Access Compliance Report

Public Rights-of-Way

(Curb Ramps)

Intersection ID: 17088	Main Street: CRAIG_AV	Cross Street: LOMAX_AV	Location:	N
ADA ID: 7504674A226F	Ramp Type: Para	Initial Pass/Fail: Fail	Overall Compliance: No	Severity Score: 25

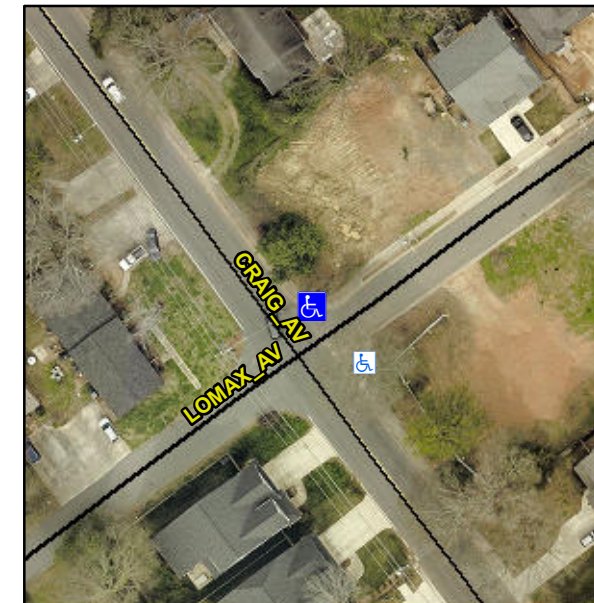
LT RP < 5%

R304.5.3, R304.3.2

Remove & Replace Entire Ramp.
